- rev.a - April 2018 - position of rooflights & parking amended
- rev.b - Nov 2018 - double doors added to N elevation, light positions shown, siting of development amended as to drawing no. 08/603/25 by 60044

SITE/ROOF PLAN (superseded)

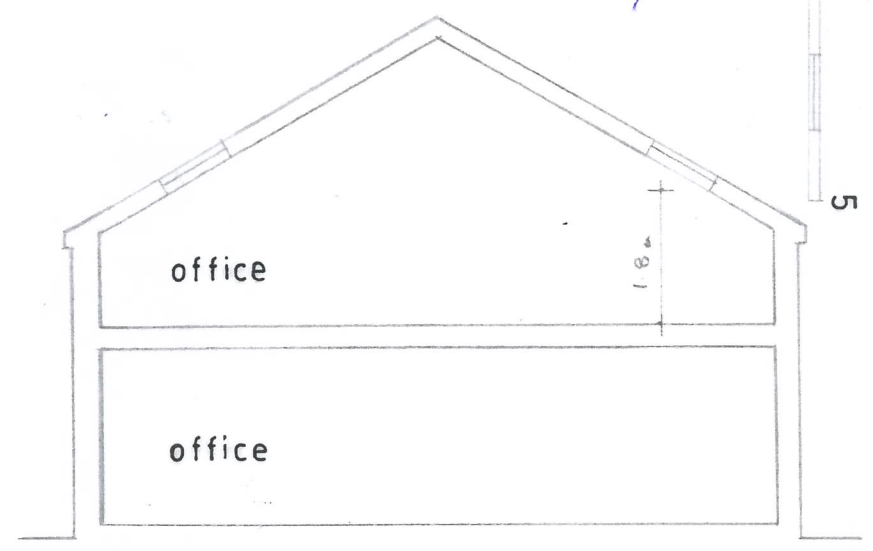
ROOF PLAN - SEE DRAWING 08/603/25a
 Changes: Building slightly repositioned
 Two parking bays added.
